**RE: Dreamstyle Warehouse, 1525 Renaissance Center
Grading and Drainage Plan
Engineer's Stamp Date 7-15-2015 (File: F16-D051A)**

**RE: DREAMSTYLE WAREHOUSE
1525 RENAISSANCE CENTER
GRADING AND DRAINAGE PLAN (F16-D051A)**

TRACT 9A RENAISSANCE CENTER GRADING AND DRAINAGE PLAN	DRAWN BY BJF DATE 06/18/15 2015009-GRB
	TIERRA WEST, LLC 5571 MIDWAY PARK PLACE NE ALBUQUERQUE, NM 87109 (505) 858-3100 www.tierrawestllc.com	SHEET # D2 JOB # 2015009

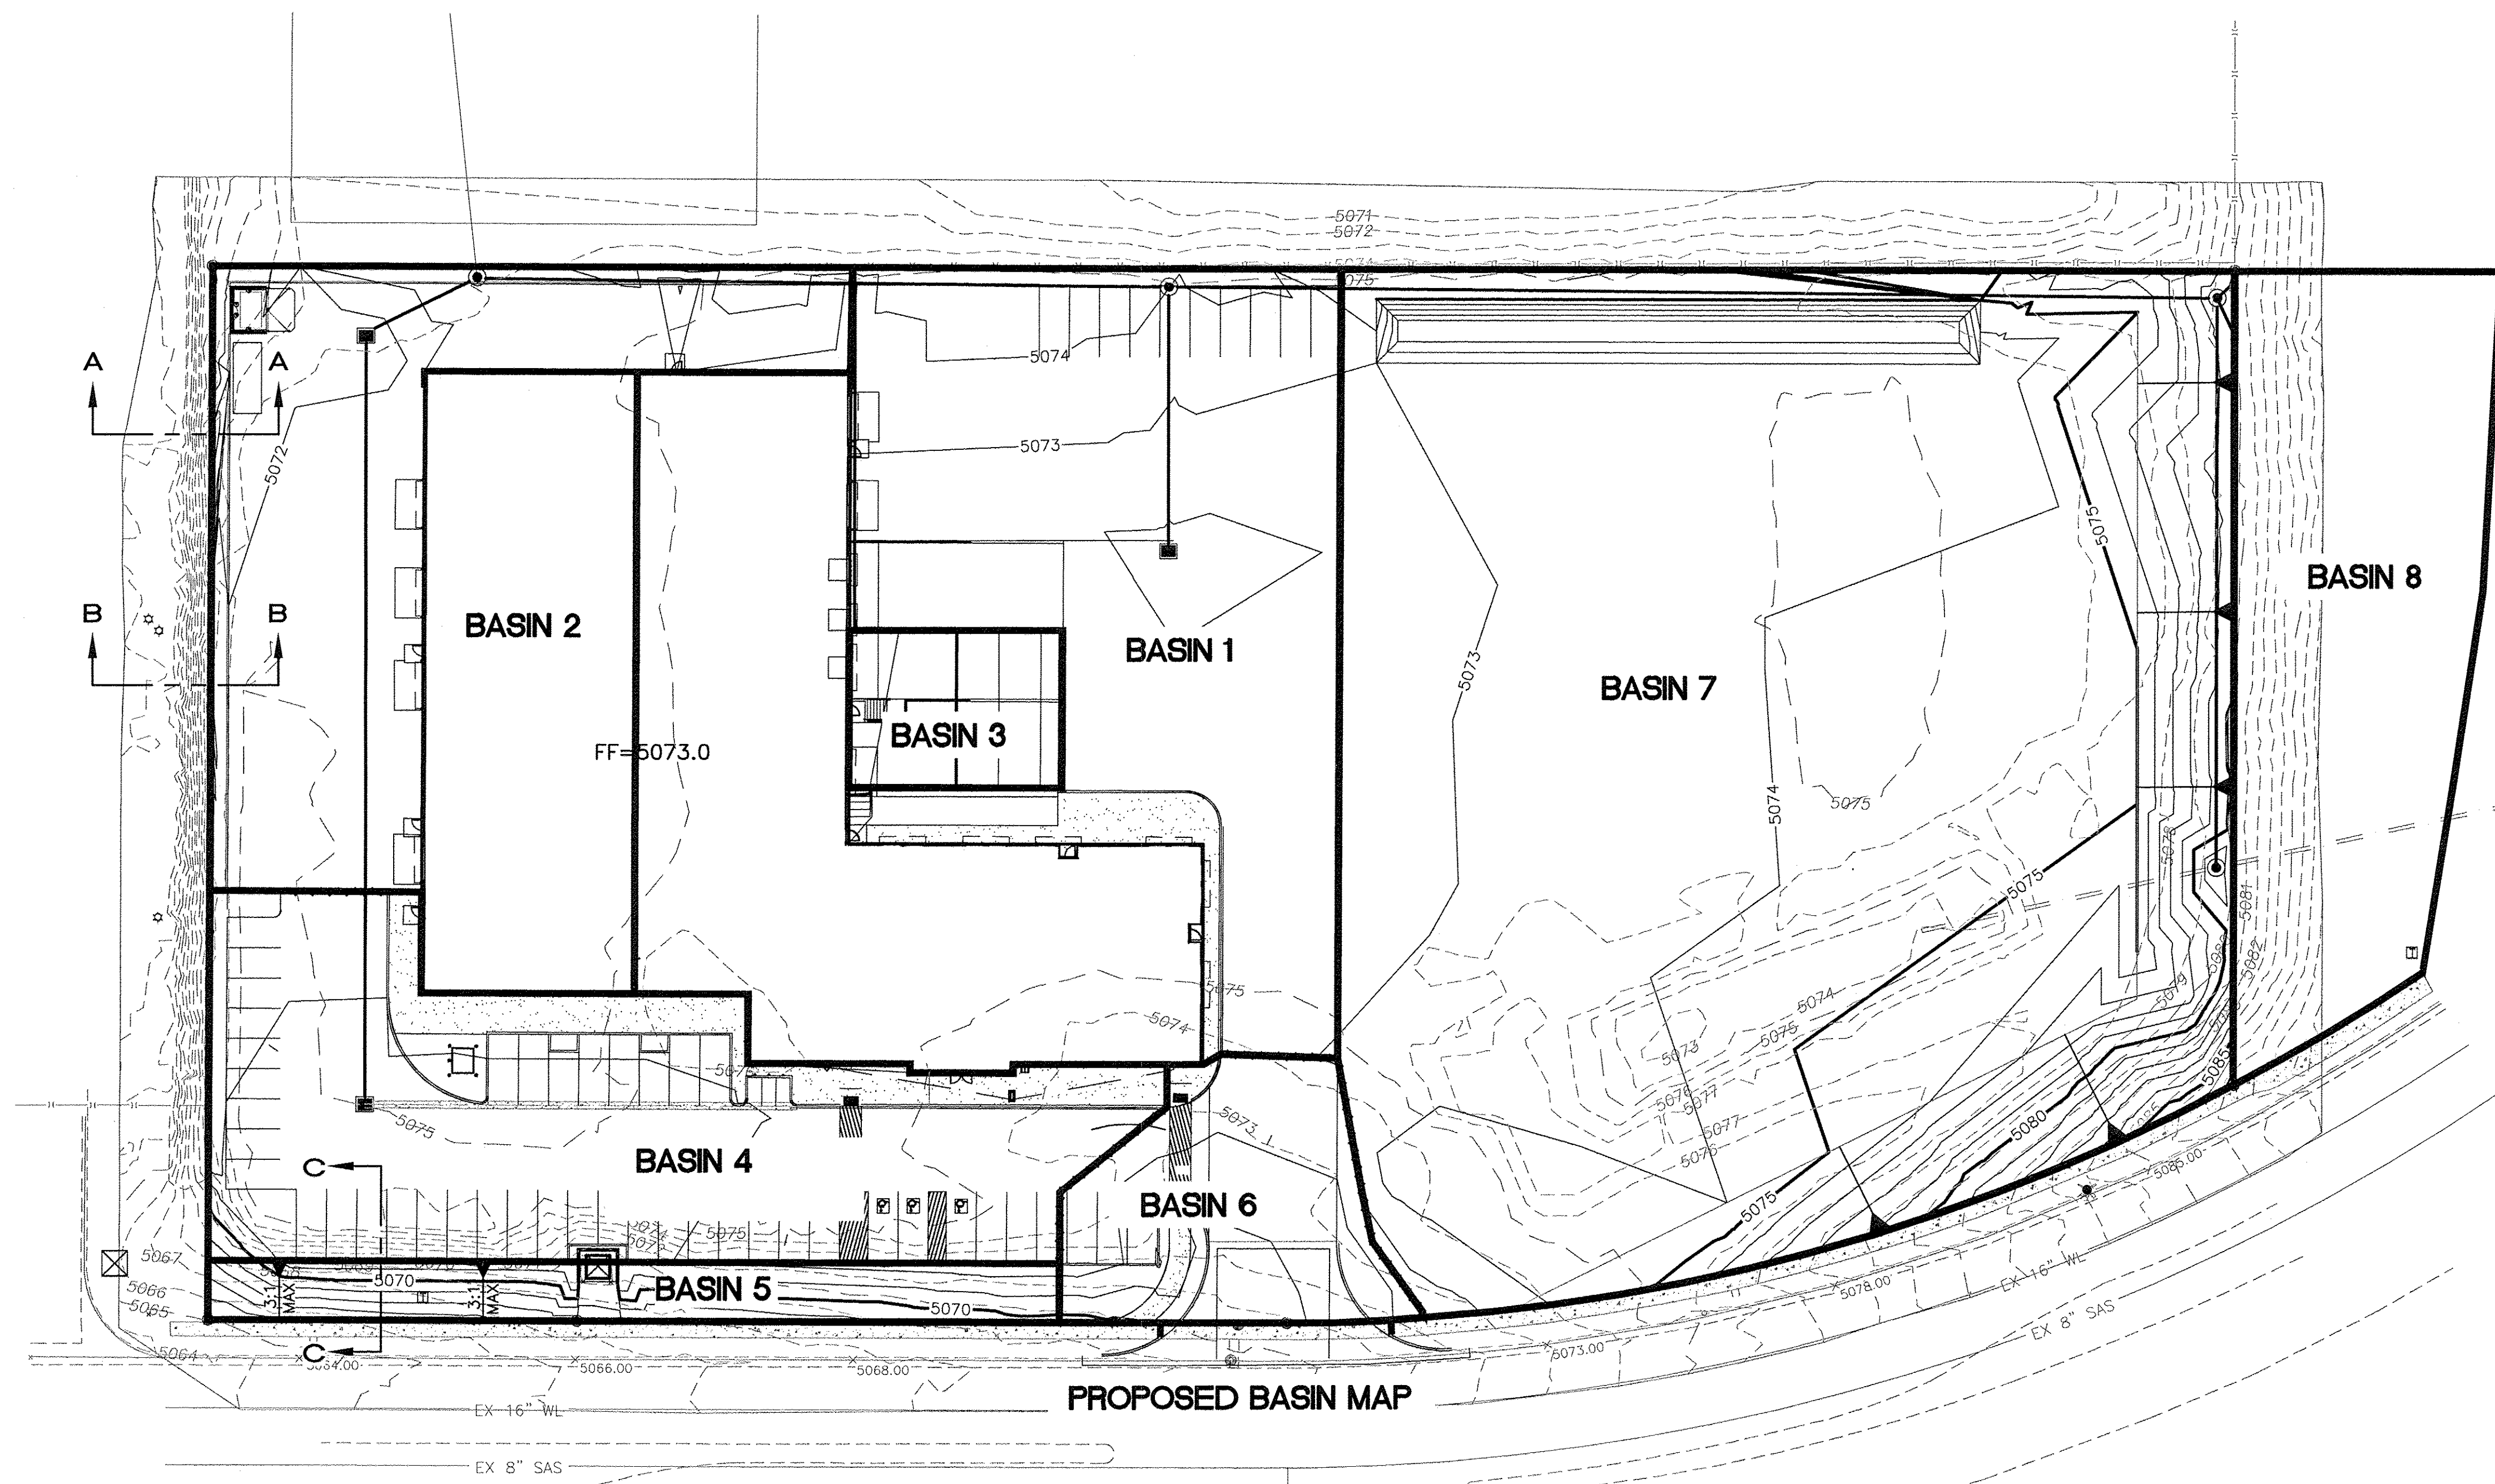
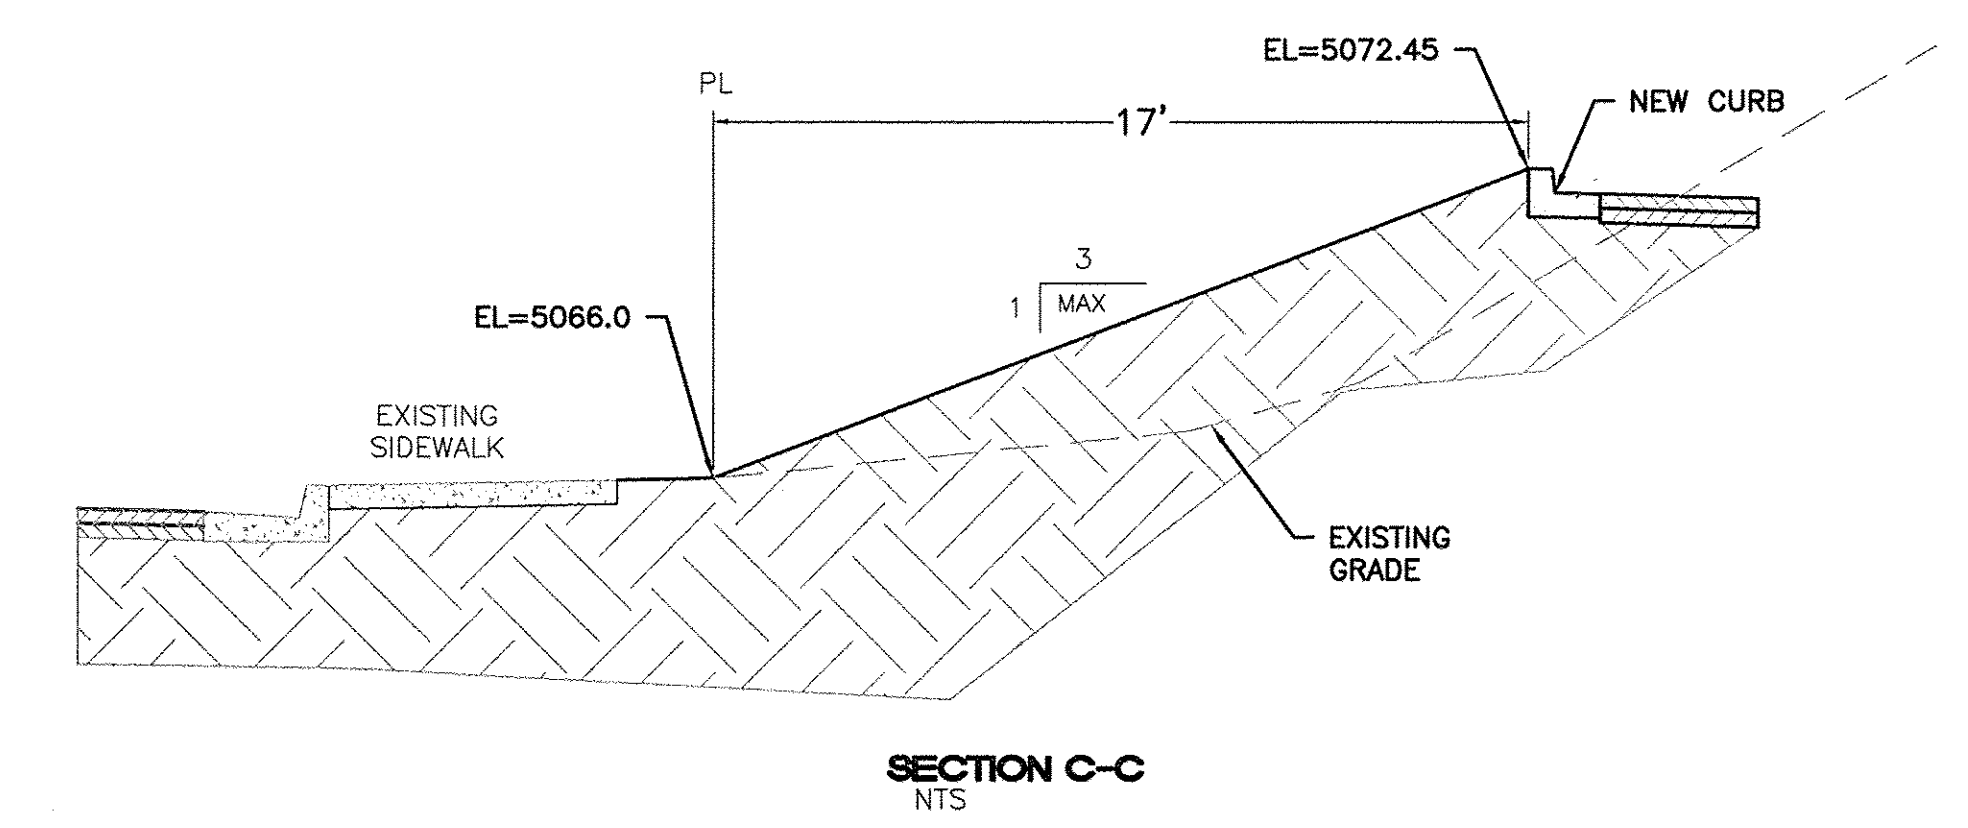
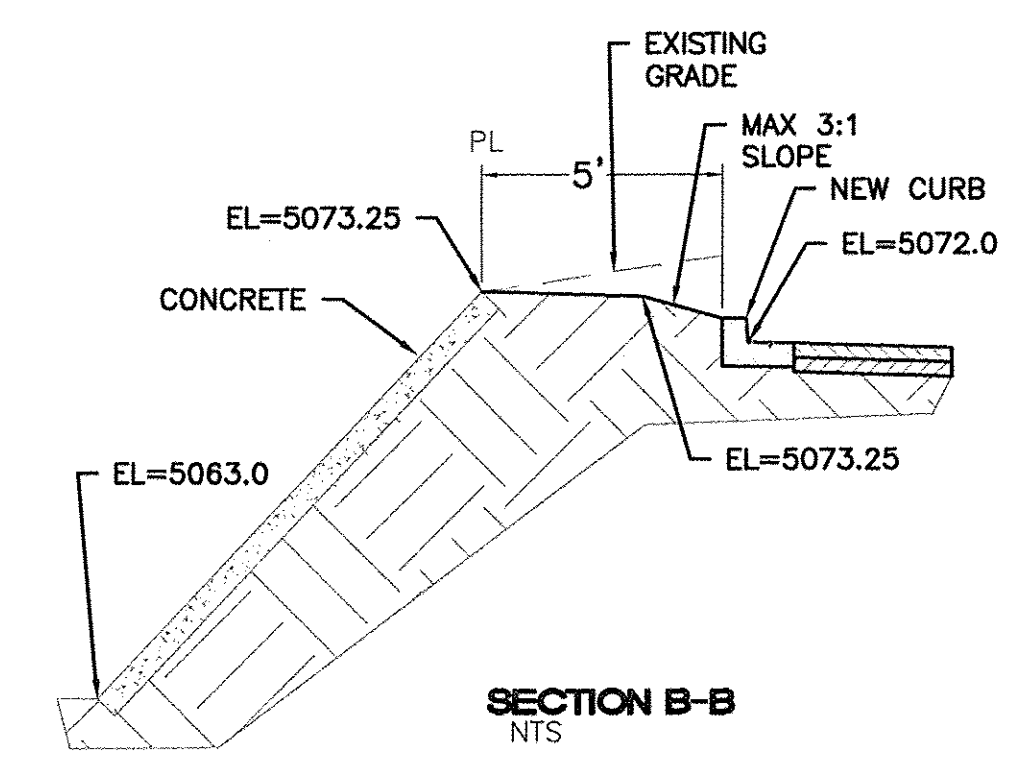
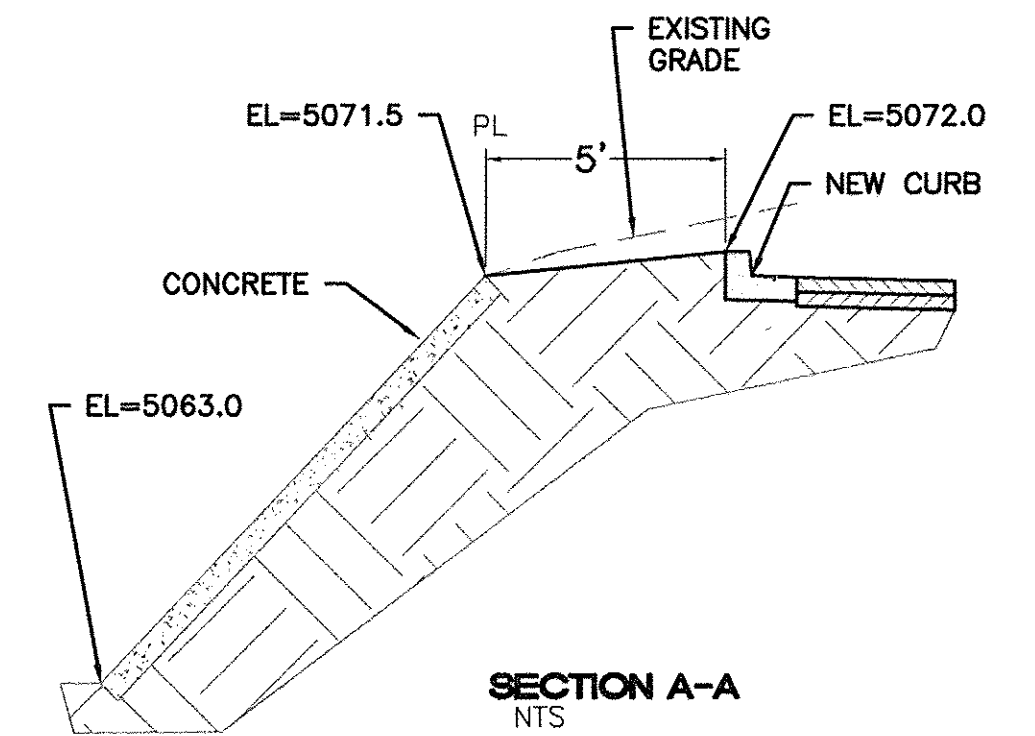
- 1) The drainage easement per the provided plat covers surface drainage only. A separate paper easement is required for the underground proposed storm drain that routes flows from off-site. Show the new easement on the grading and drainage plan.
- 2) On a more minor note, the water block labels need to be revised to point to the new waterblock location near the new entrance. Make sure that both the single D inlet from the previous submittal and the new double D inlet calculations are shown on the newest plan.

1. Provide plat for Tract 9A that may show a private easement for the proposed storm drain that routes off-site flows through site. If one is not already provided, a paper easement is required.
The plat is enclosed and shows a blanket drainage easement already exists for the site. The easement covers the pipe/pond as well as surface drainage.
2. In order to control the flow to allowable discharge of 0.66 cfs to the street, revise grades at the entrance.
The grades around the entrance were revised and the total discharge to the street is 0.66 cfs, which matches the allowable discharge amount.
3. The Type "D" drop inlet upstream of Pipe 3 does not show the capacity to handle the amount of flow listed for Pipe 3. Label curb along the west edge and other parking areas if applicable, and have a general note stating that the listed elevations are at the flowline as

applicable. (There is a discrepancy between the spot elevation of 5071 -40 and the grate elevation of 5071.25 near the northwest corner of the new building where the 5071.25 elevation appears to provide sufficient head to capture the required flow.)

4. **The curb is not called out on the plans as 6-inch header curb. The drop inlet was changed to a double inlet, which has capacity to handle the flows, and the call out for the other drop inlet was changed to match the spot elevation given at that location.**
